GENERAL ARRANGEMENT PLAN
31 FLOOR
SCALE 1:100

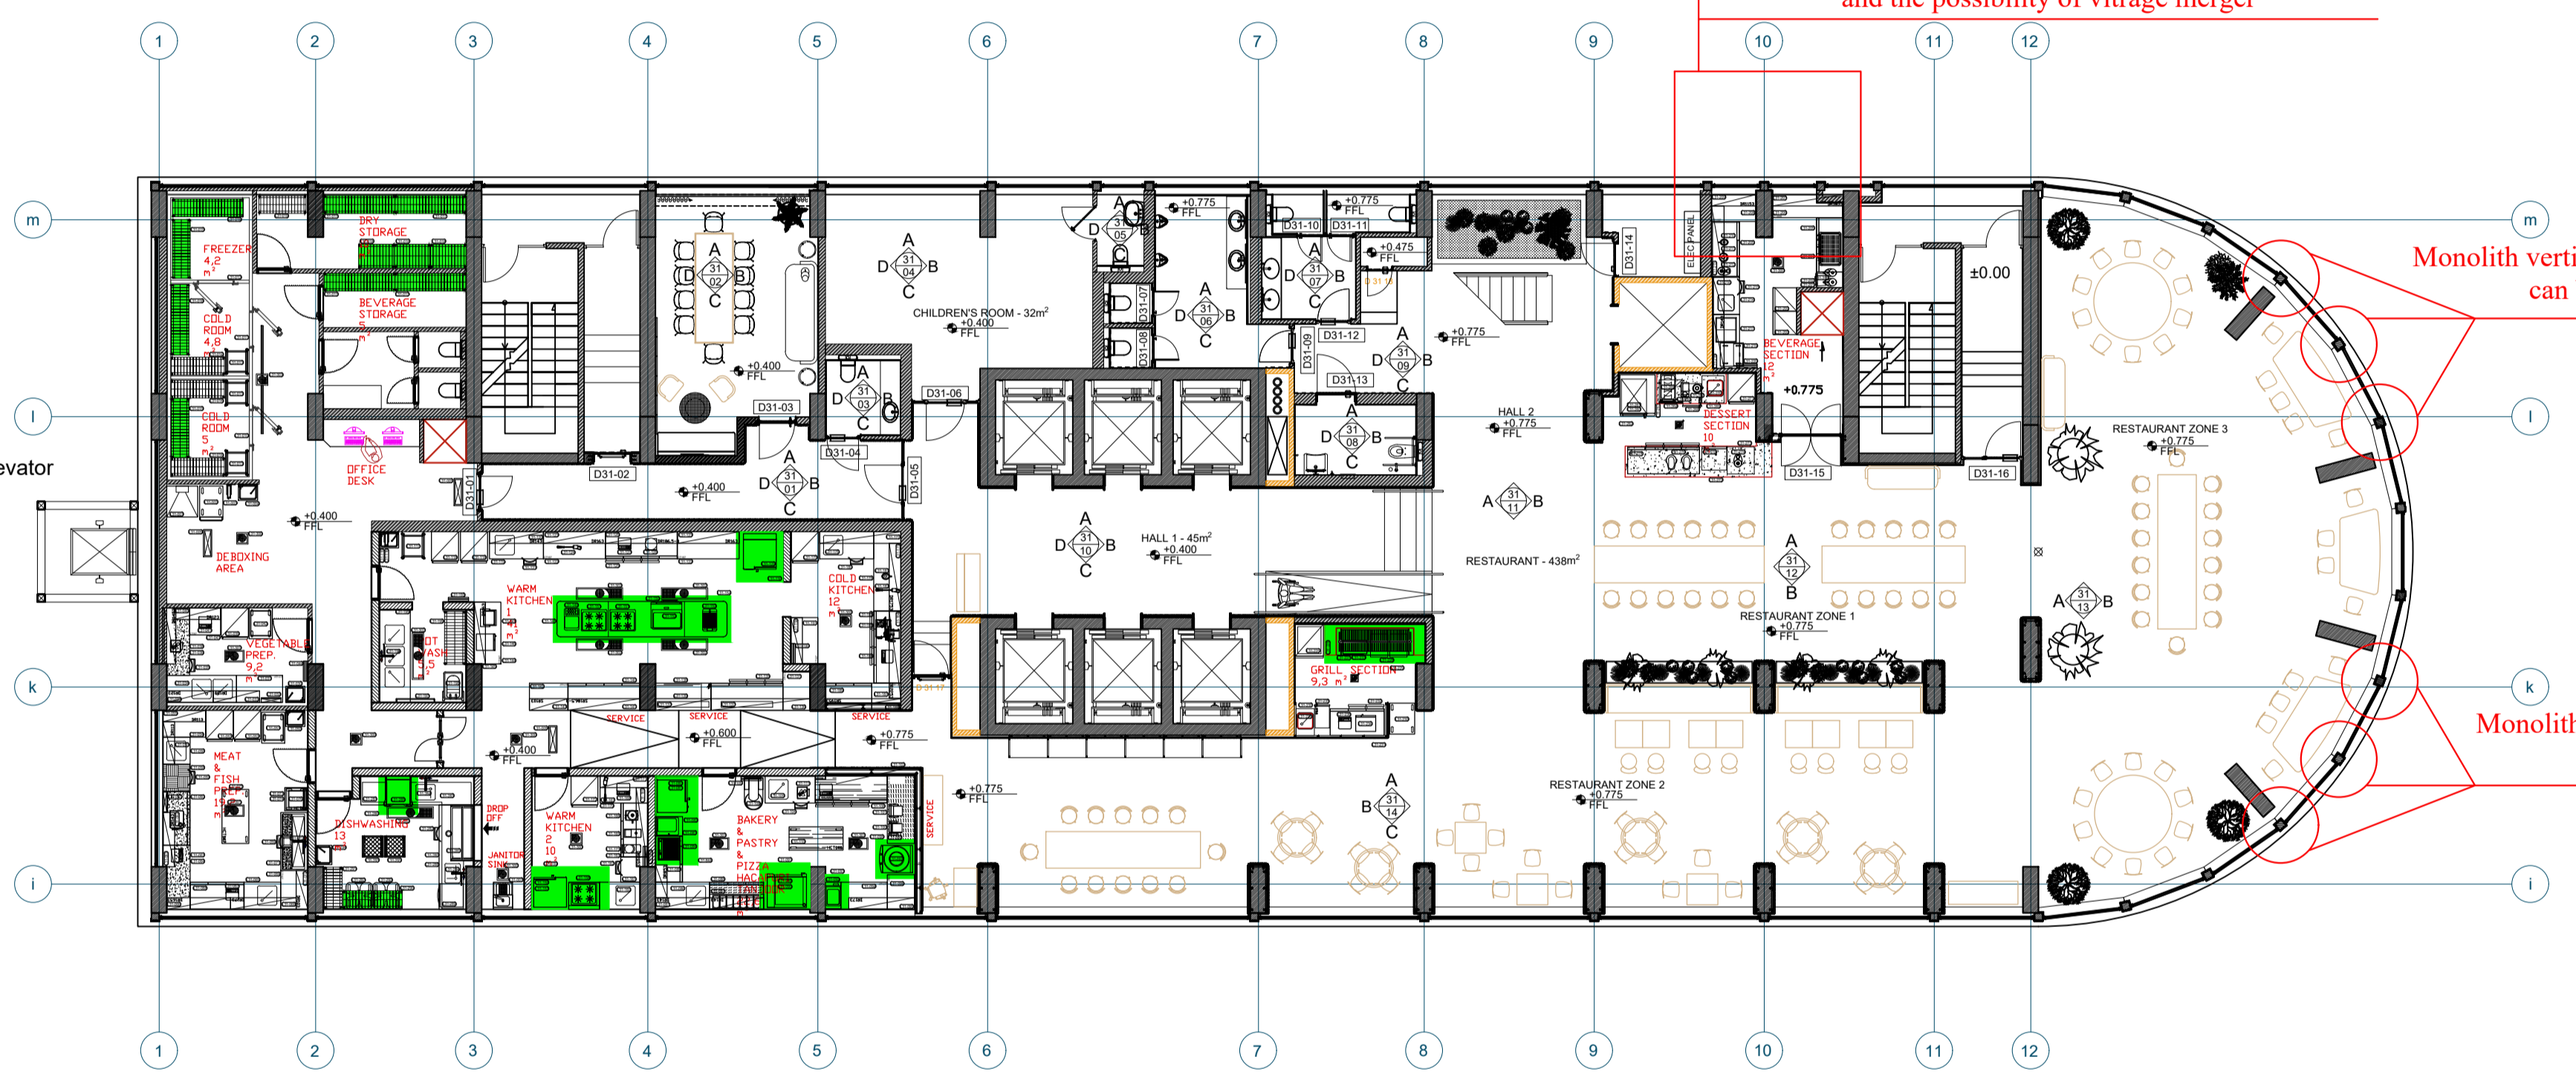
Supplier shall consider existing planning with partitions and the possibility of vitrage merger

Monolith vertical columns shall be allocated in a way, so that windows can be arranged symmetrically between the pylons

Monolith vertical columns shall be allocated in a way, so that windows can be arranged symmetrically between the pylons
